**SUBJECT: URBAN DESIGN ADVISORY GROUP COMMENTS TO THE DRAFT
ENVIRONMENTAL IMPACT STATEMENT**

INTERSTATE 5 COLUMBIA RIVER CROSSING

DRAFT -Design Guidance for the Columbia River Crossing Project

Exhibit 3-2. North Portland Harbor Crossing

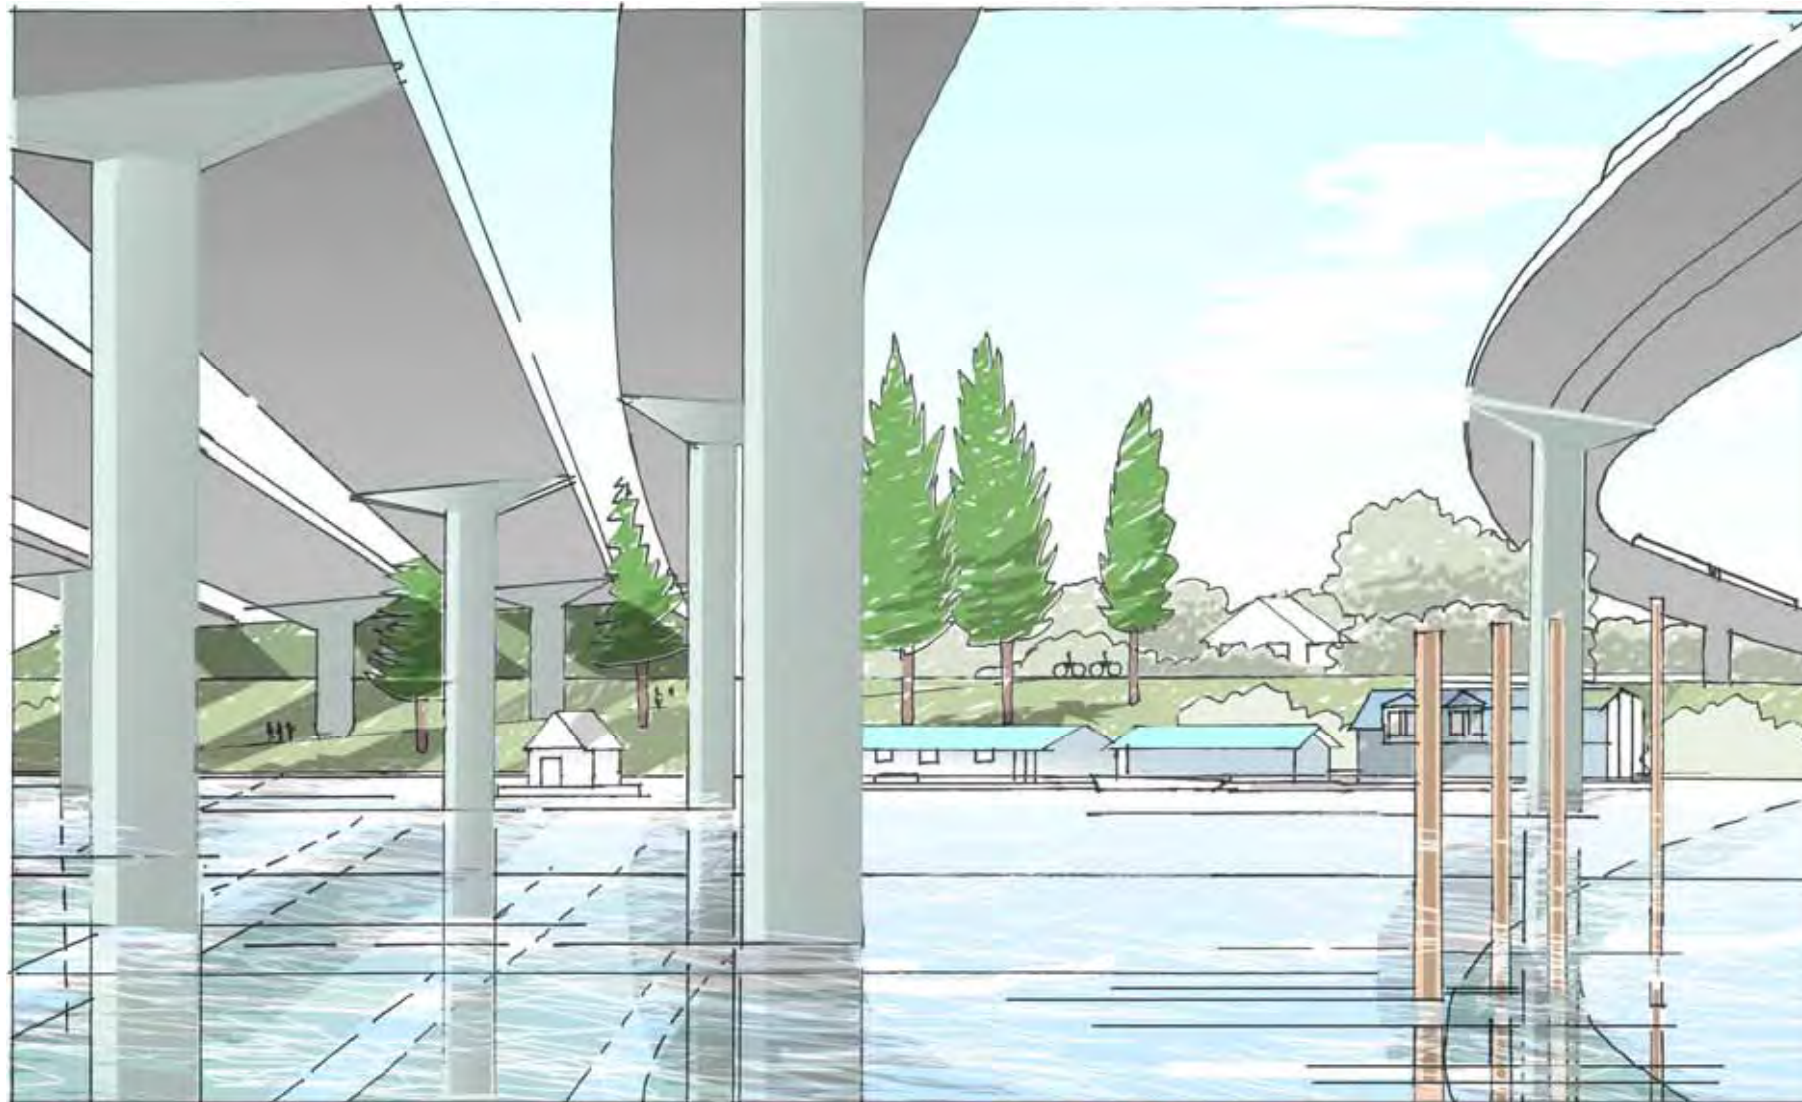
5. Improve pedestrian and bicycle access along the south bank of the North Portland Harbor under the highway with adequate headroom and lighting, thus connecting Bridgeton to the 40-mile loop. Provide safe and convenient access to the Expo transit station. *Improve waterfront trails.*
6. Minimize piers in North Portland Harbor and consider bridge types independent of the constraints that shape the bridge over the Columbia River. *Consider other bridge types with fewer columns in the water.*
7. Construct the highway ramp and transitway spans over the North Portland Harbor as light and elegant bridges. Their architecture need not reflect that of the main highway spans. *Make detached bridges light and elegant.*
8. Preserve highway views towards Mount Hood. *Preserve views to Mt. Hood.*

14. Plan for future addition of a local traffic, bicycle and pedestrian bridge across North Portland Harbor east of the highway, location to be determined (This is not seen as part of the

CRC project, but something that should be planned for now). *Anticipate a local traffic bridge over North Portland Harbor.*

Exhibit 3-3. Hayden Island LRT Station and I-5 Crossing

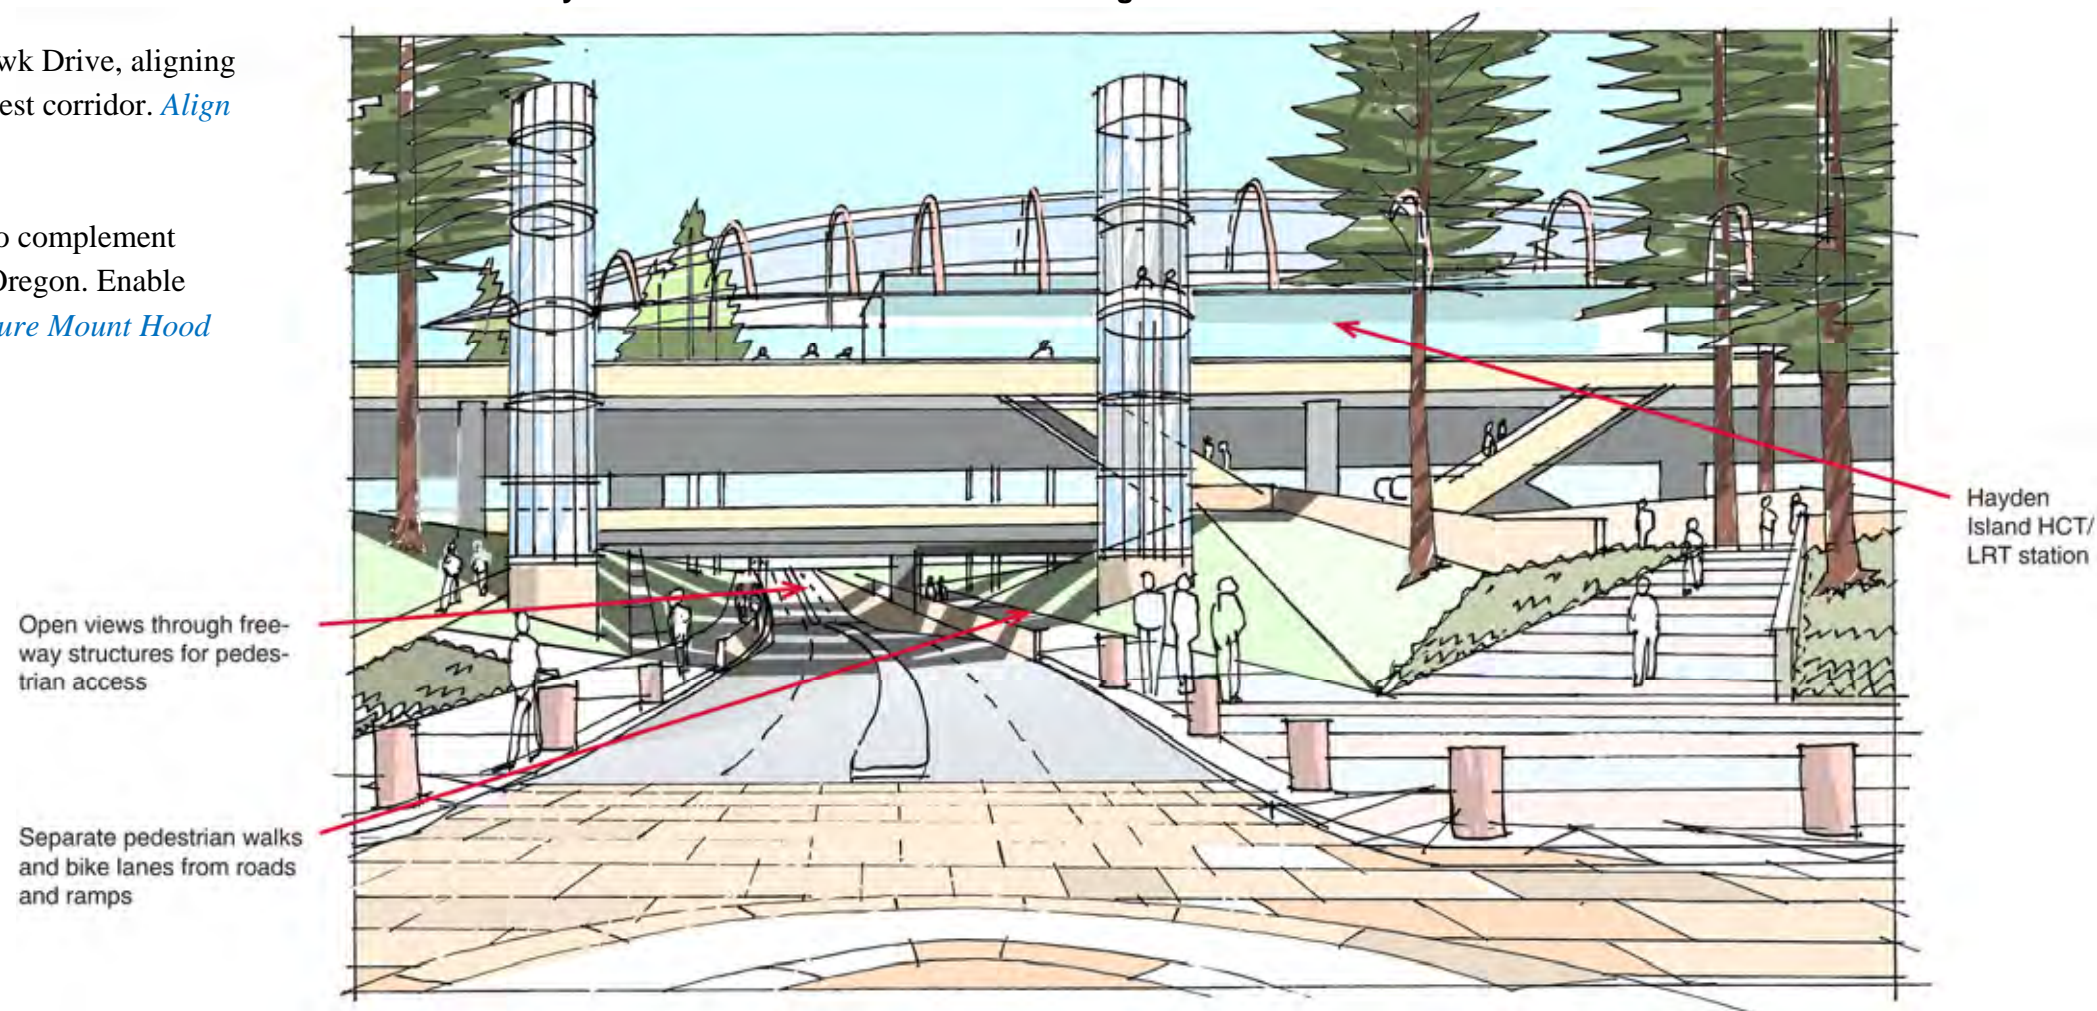
11. Locate the station directly above Tomahawk Drive, aligning access and landscape with the planned east-west corridor. *Align transit station with Tomahawk Drive.*

15. Increase separation between ramps at the Hayden Island interchange to enable creation of generously planted landscaped terraces. Use this landscape also for natural treatment of storm-water runoff. Design noise walls and berms integral with the interchange to reduce noise trespass to the east and west. *Space ramps to admit daylight and generous landscaping.*

Exhibit 3-5. Columbia River Spans

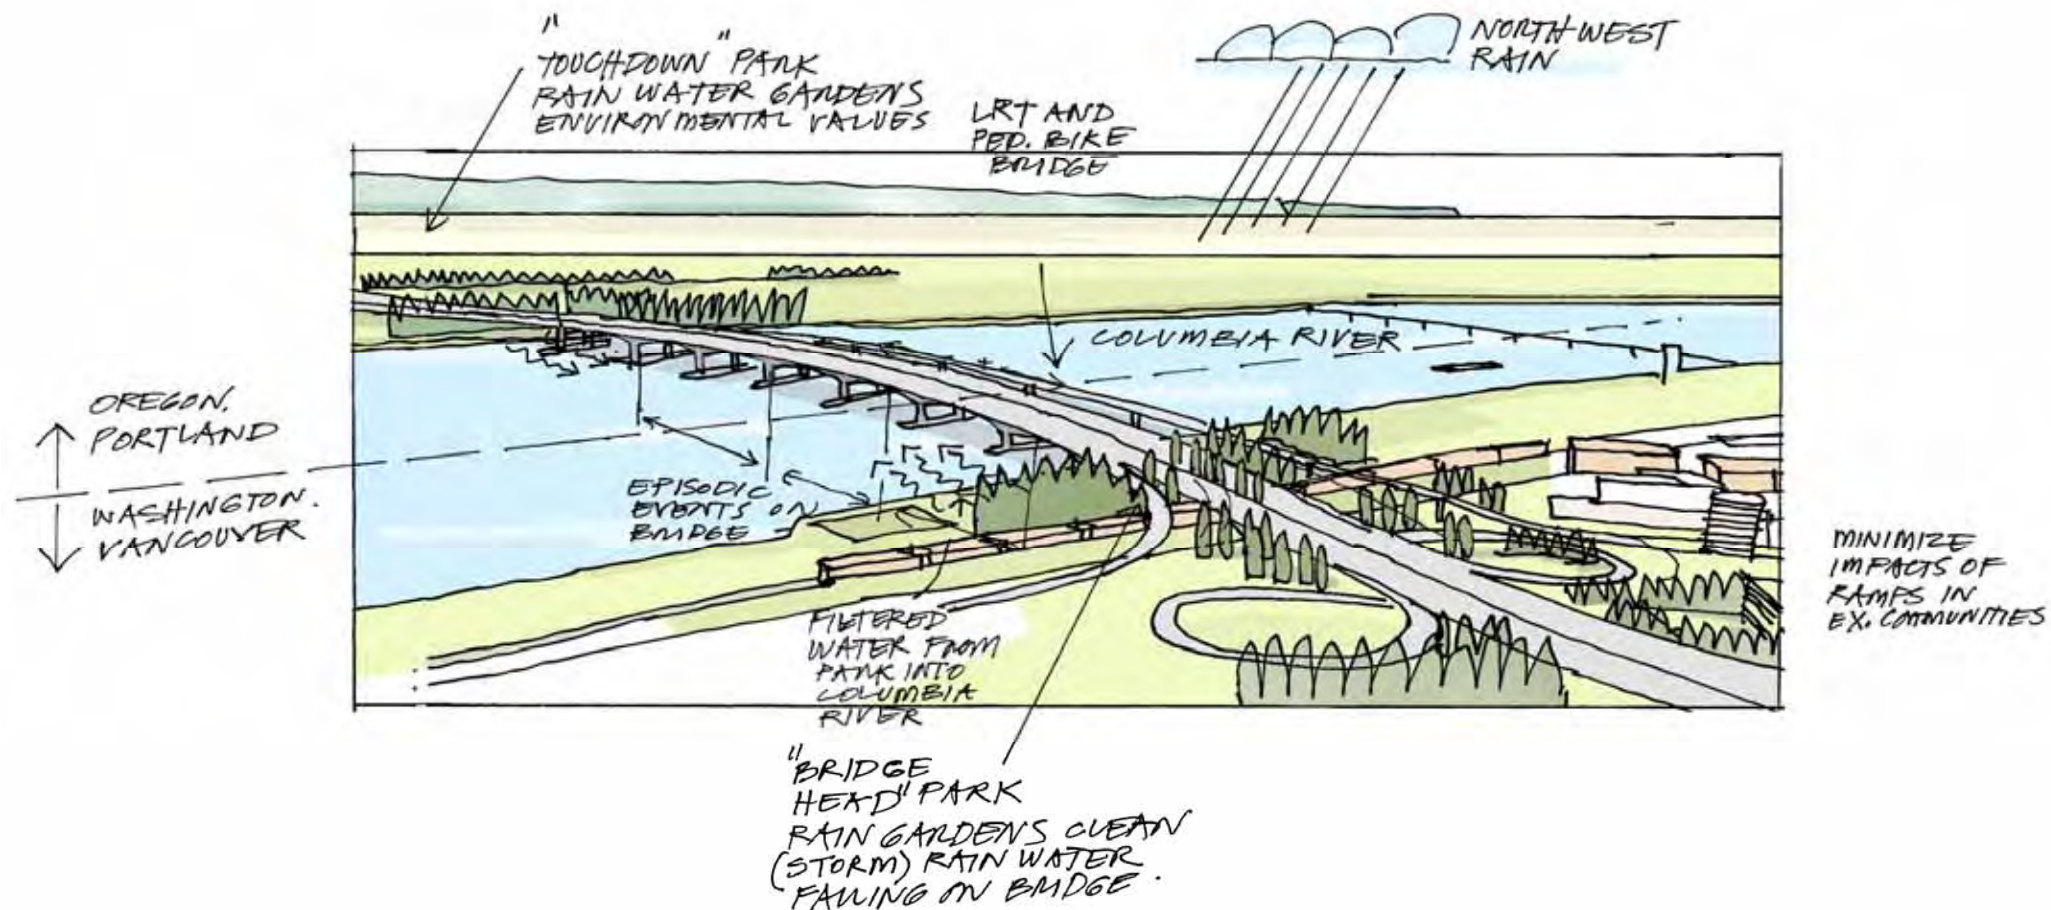
16. Members of the UDAG recommend that the FAA be approached to consider a greater height allowance for the north end of the CRC span, permitting consideration of bridge types other than girder and box-girder. (It has been suggested that an element of interpretation by FAA staff has been involved in setting the imaginary surface height restrictions, and that a different interpretation might change the limits on bridge type). *Challenge aviation height limits.*

21. Consider design opportunities on the south parts of the span that are relatively unconstrained in height. (FAA height limitations related to Pearson Field have effectively reduced bridge type selection to a single choice: box girder bridge. This might suggest a non-symmetrical bridge design or inclusion of an iconic object associated with the river crossing. Astoria Bridge demonstrates use of two distinct bridge types, one of limited height, the other much higher. Such options do not appear to have been considered for CRC). *Consider other bridge types south of the Pierson Airfield constraints.*

22. Use landscape and controlled views to build anticipation of the river crossing in those approaching the main span. *Design dramatic approaches to the river crossings.*

Exhibit 3-6. North Bank & SR 14 Interchange

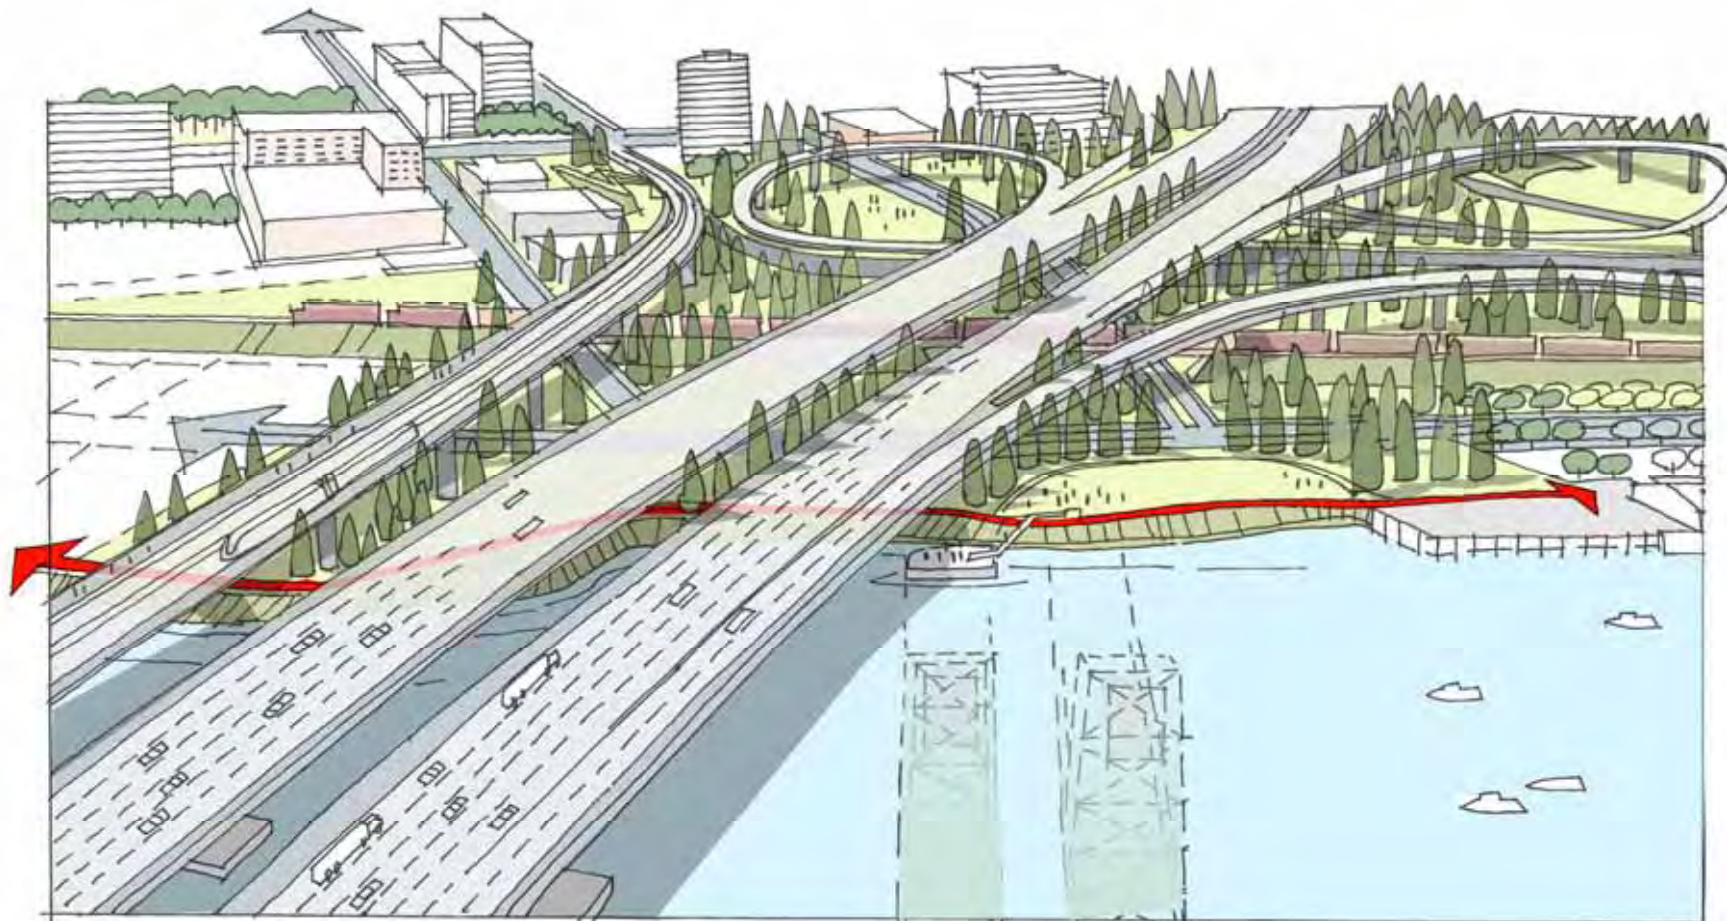
23. Redesign the river bank at the former bridgehead under I-5 and the Red Lion site as urban park space in which people can meet, enjoy views, and otherwise use this shoreline destination. *Reconfigure the under-bridge as destination public open space.*

24. Investigate options for regrading and redesign of the river bank under the highway, including options for retention of fragments of the old bridges. *Investigate different under-bridge designs*

25. Designate a continuation of the regional trail through this space. *Include continuation of the waterfront trail.*

Exhibit 3-8. Seventh Street Footbridge

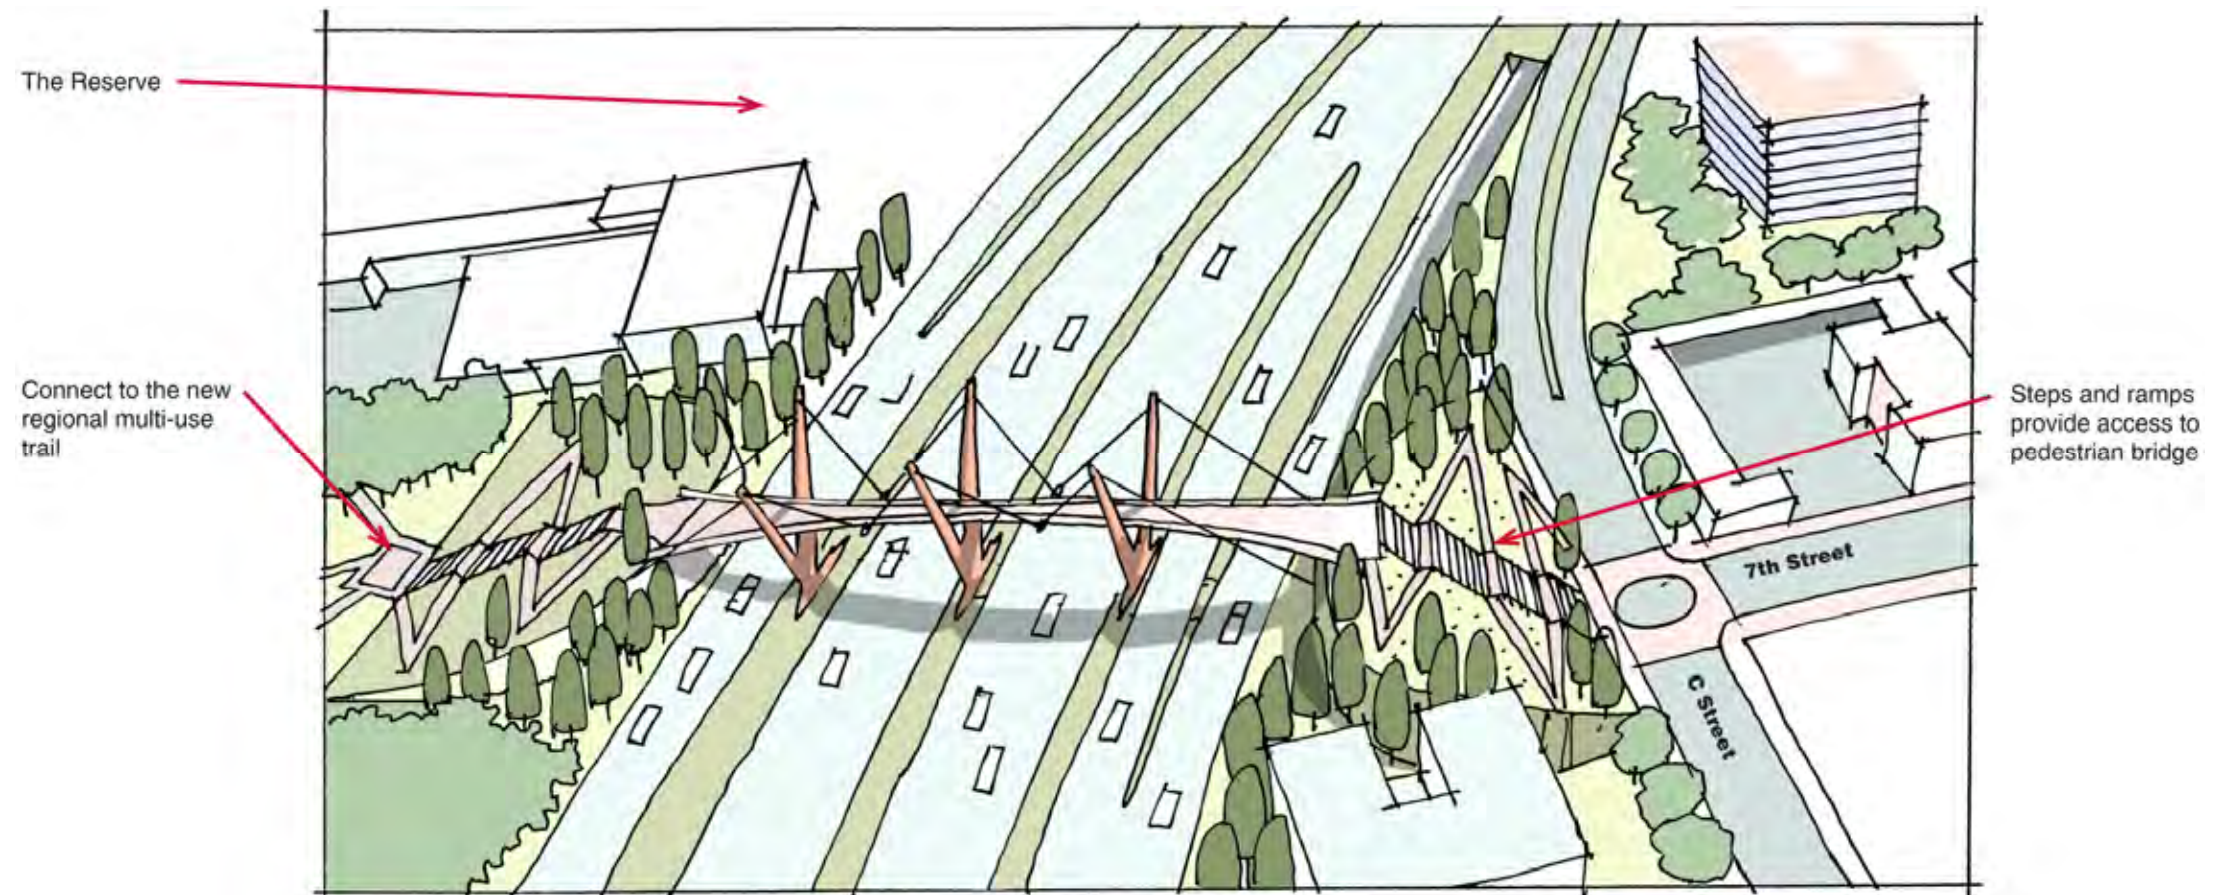
34. Consider the design of the 7th Street footbridge as an opportunity to announce approach to the bridge with an elegant and colorful structure. *Make the footbridge a colorful gateway.*

35. All of the Downtown highway crossings should be addressed functionally and visually as an integrated system. *Consider the collective appearance and function of Downtown crossings.*
